**CITY OF BOULDER
WATER RESOURCES ADVISORY BOARD
AGENDA ITEM**

AGENDA TITLE: Public hearing and consideration of a recommendation to City Council regarding the Skunk Creek, Bluebell Canyon Creek and King’s Gulch Floodplain Mapping Update

DATE: February 5, 2015 **ACE PROJECT NO.:** COBLDR16
TO: Katie Knapp, City of Boulder Planning and Development Department
FROM: Brian Van Zanten, Anderson Consulting Engineers, Inc. *BLV*
Greg Koch, Anderson Consulting Engineers, Inc. *GTK*
SUBJECT: Peer Review – Skunk Creek, Bluebell Canyon Creek, and King’s Gulch Request for Physical Map Revision Report, Boulder, Colorado

This letter provides responses to the comments provided by Anderson Consulting Engineers as part of their peer review regarding the Skunk Creek, Bluebell Canyon Creek, and King's Gulch Request for Physical Map Revision – Hydraulic Report, dated August 1, 2014. A revised Hydraulic report will be provided under separate cover.

Skunk Creek, Bluebell Canyon Creek, King's Gulch
 Request for Physical Map Revision (PMR)
 Figure 4.9: Floodplain Workmap

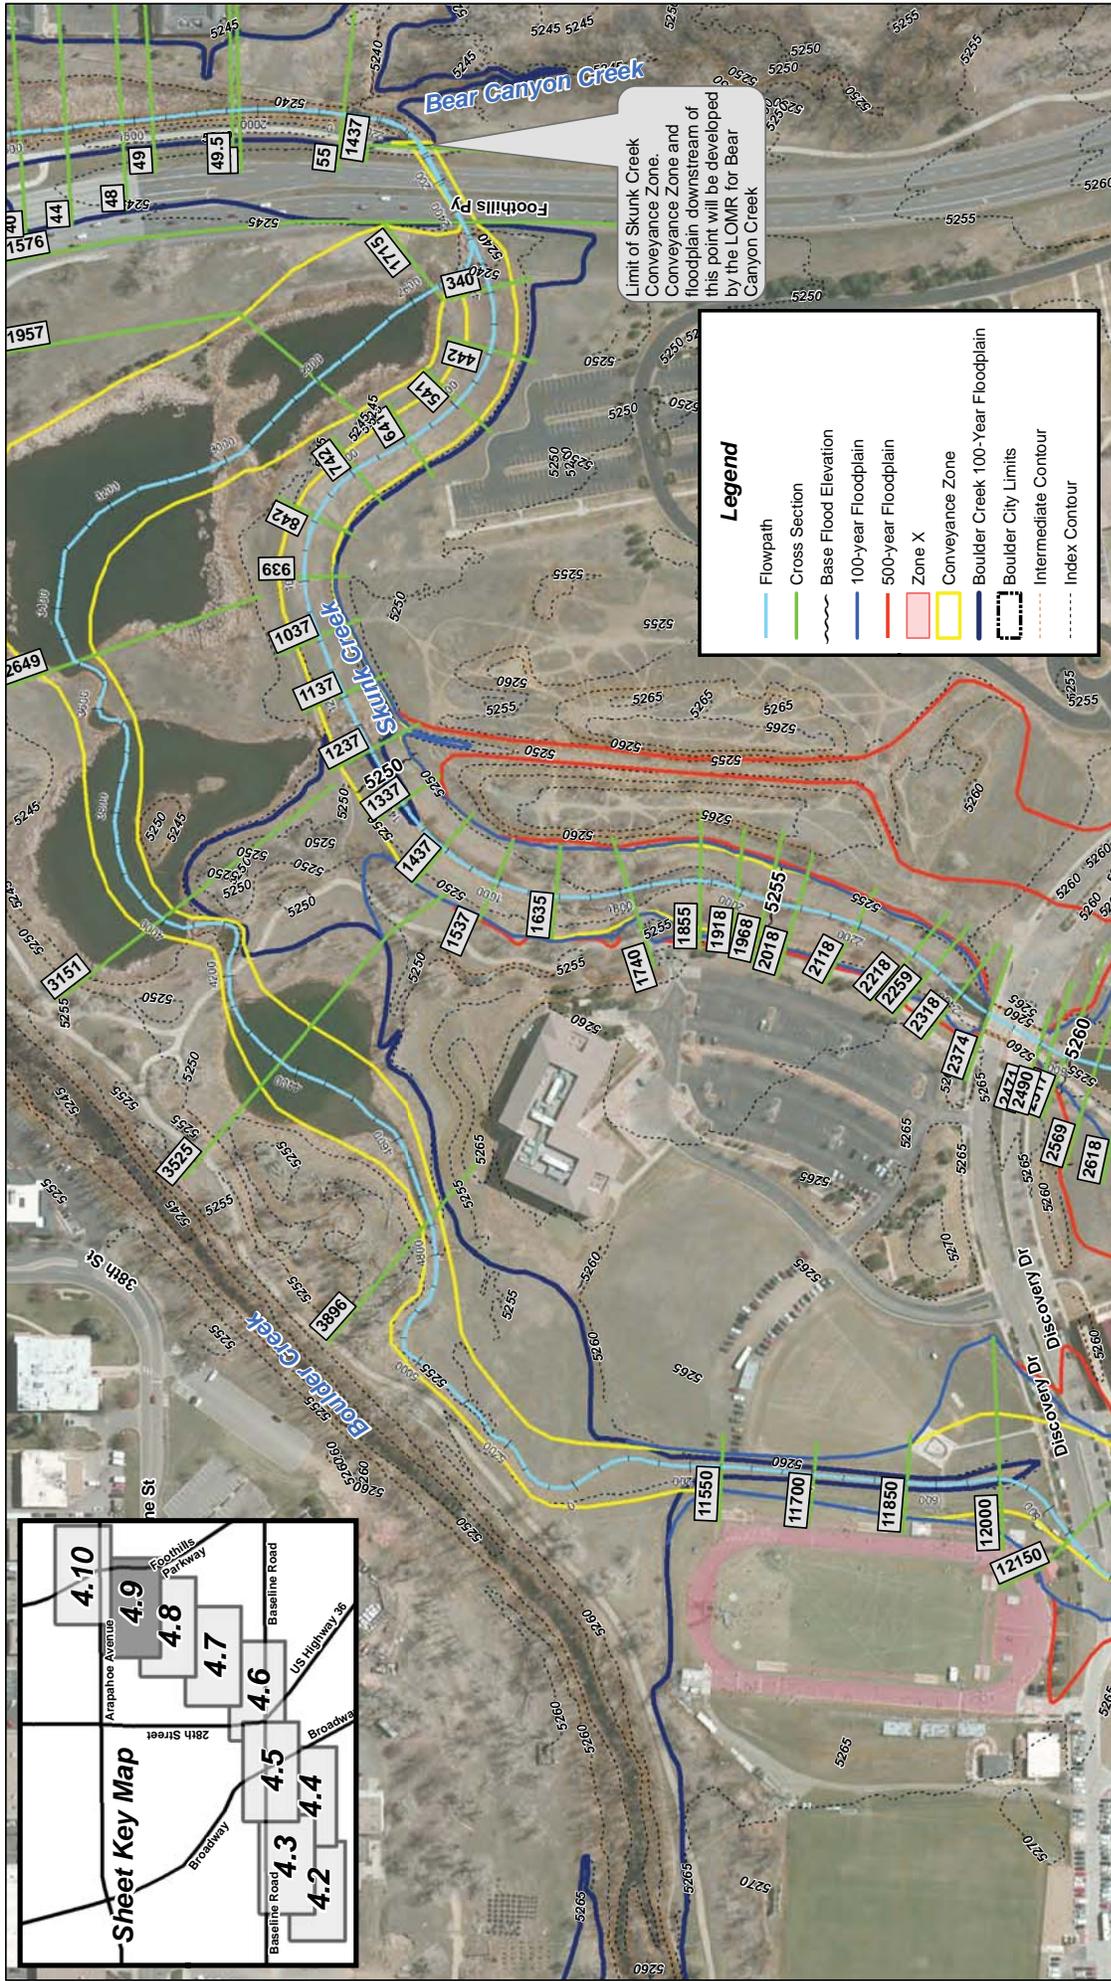
- (1) According to the HEC-RAS model, 100-year flows begin spilling over the left overbank on the main Skunk Creek flow path downstream of Cross Section 1437. Figure 4.9 depicts the 100-year floodplain boundary extending past this point to Cross Section 1237. Please revise as necessary.

- 51. According to the HEC-RAS model, 100-year flows begin spilling over the left overbank on the main Skunk Creek flow path downstream of Cross Section 1437. Figure 4.9 depicts the 100-year floodplain boundary extending past this point to Cross Section 1237. Please revise as necessary.**
